BRACEWELL ENGINEERING, INC.

Re: Comments to Response to Citation No. 02-05-02C-010, San Juan Bautista Water System

Source Capacity vs Demand Analysis

FIGURE 1
PROJECTED WATER DEMAND

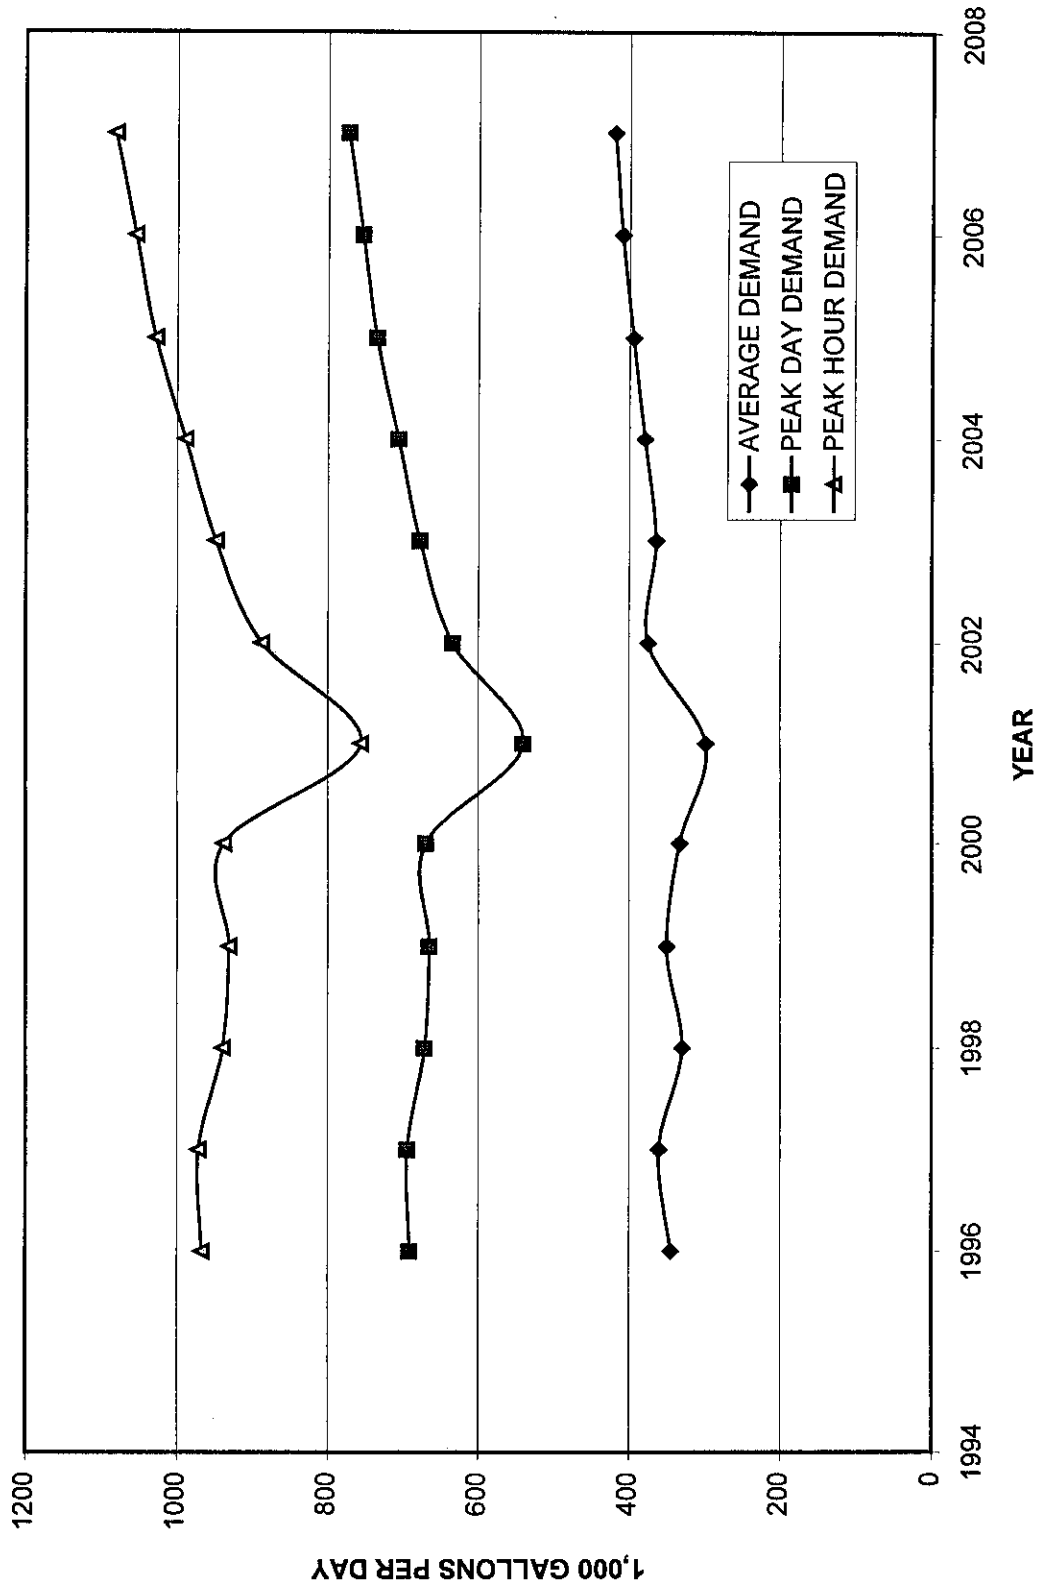
1. The Peak Demand in our previous analysis of source capacity versus demand is a maximum day demand. We read the flow meters at the well heads several times each week but do not have any hourly demand data. At the suggestion of Jan Sweigert we read the flow meter a 6 A.M. and at 9 A.M. one day to develop a "peaking factor" which we can use for a peak hour demand analysis. Based on this method we determined a peak hour factor of 1.4. We then developed the attached peak hour demand analysis (see Table 1).

2. The analysis started with the historical demand data and projected demand based on the outstanding building permits and planned development projects in San Juan Bautista. From these we determined a water usage increase of 23,000 gallons per day (gpd) in 2003, 15,000 gpd in 2004, 10,000 gpd in 2005 and 10,000 gpd in 2006. The previous analysis of peak demand projection did not include a maximum day peaking factor applied to the demand caused by the projected population increase. Based on the historical data, a maximum day peaking factor was determined and applied to the projected future increase in maximum day demand. A corrected demand projection is attached.
